## BID PACKAGE #2 ADDENDUM #01

**DATE:** December 5, 2024      **PROJECT NO:** 24-038  
**TO:** Gramoll Construction      **PROJECT:** DTC Welding Technology Bldg  
155 S 750 W St  
North Salt Lake, Utah 84054

The original specifications and drawings, labeled “Bid Package #2”, dated November 1, 2024 and issued for the project referenced above are amended by the following content and form a part of the Contract Documents.

**PL112.2**

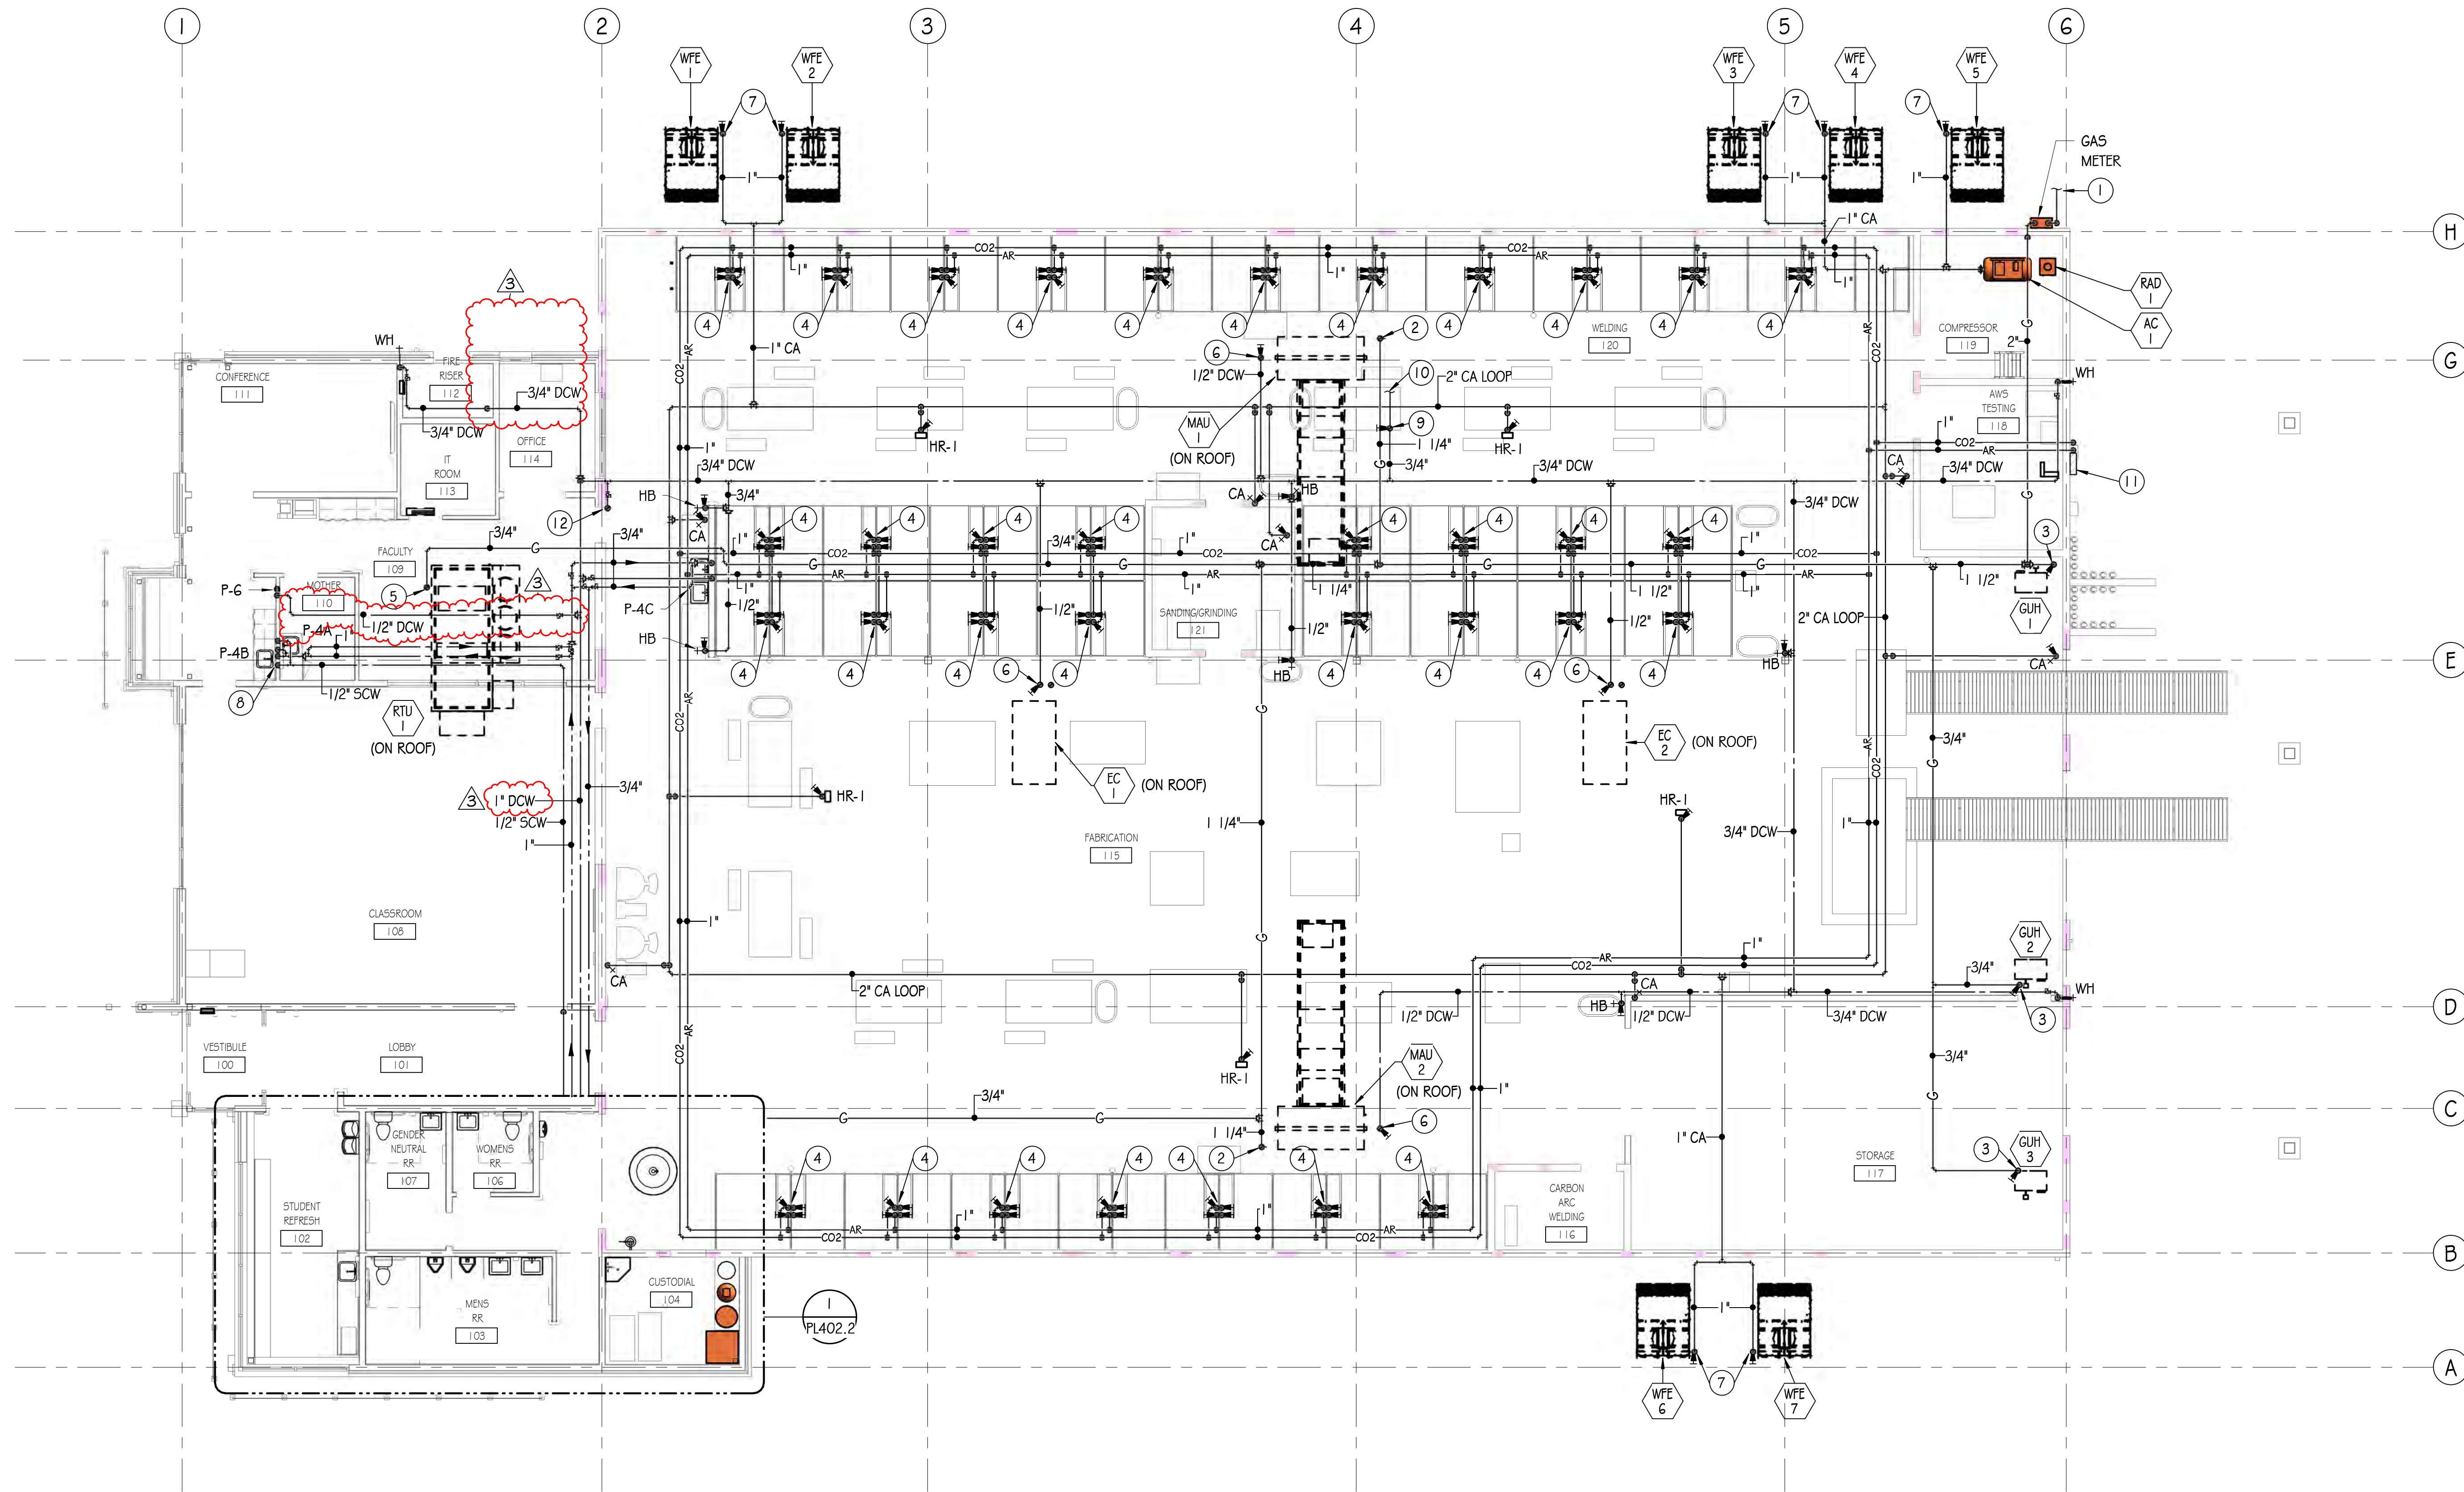
- P1.1 Reference Sheet PL112.2 - PLUMBING PLAN – WATER, GAS & COMPRESSED AIR
  - a. Moved water entry location and modified domestic cold water pipe size and routing.
- P1.2 Reference Sheet PL402.2 – ENLARGED PLUMBING PLAN
  - a. Moved water entry location to custodial room 104 and modified domestic cold water pipe size and routing.
- P1.3 Reference Sheet PL601.2 – DOMESTIC WATER FLOW DIAGRAM
  - a. Modified domestic cold water flow diagram to show new water entry location and modified domestic cold water pipe size and routing.

LEVEL 1 MECH  
PLAN -  
EXTRACTOR  
**MH112.2**

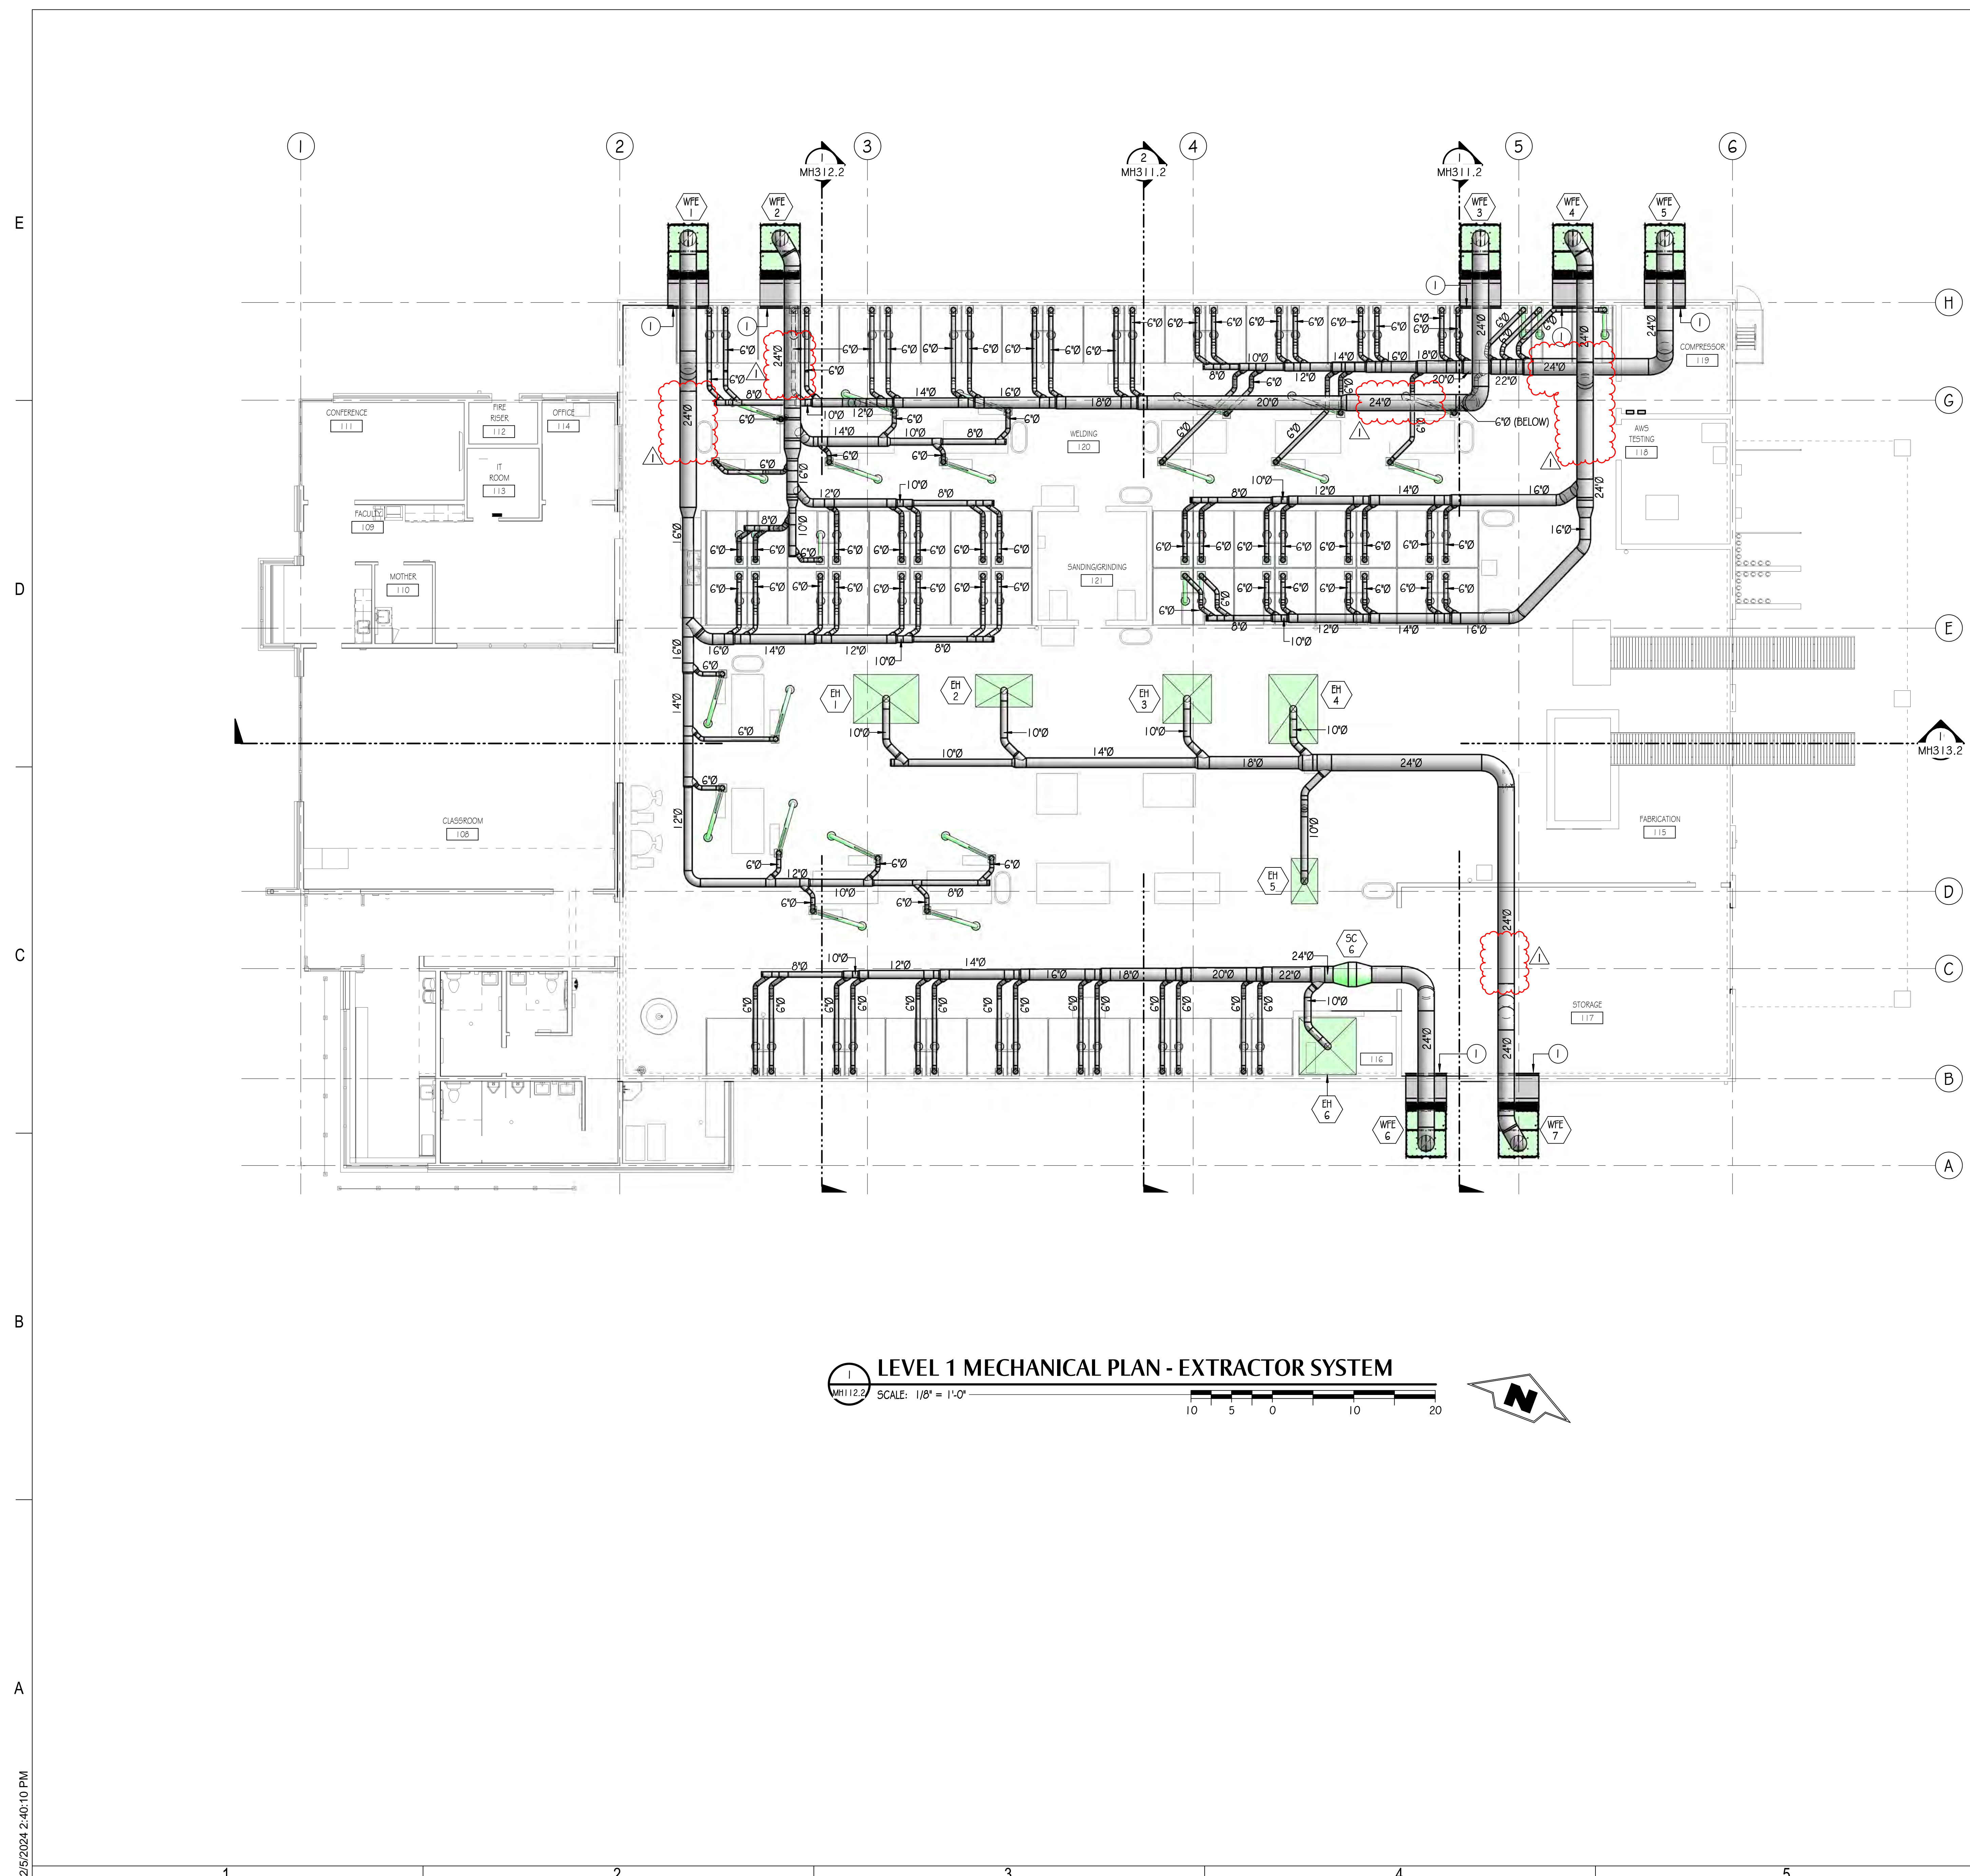
- M1.1 Reference Sheet MH003.2 - MECHANICAL SCHEDULES
  - a. Spark Cooler Schedule Updated.
- M1.2 Reference Sheet MH112.2 - LEVEL 1 MECH PLAN - EXTRACTOR
  - a. Spark Coolers SC-1 through SC-5 and SC-7 removed per owner's direction.
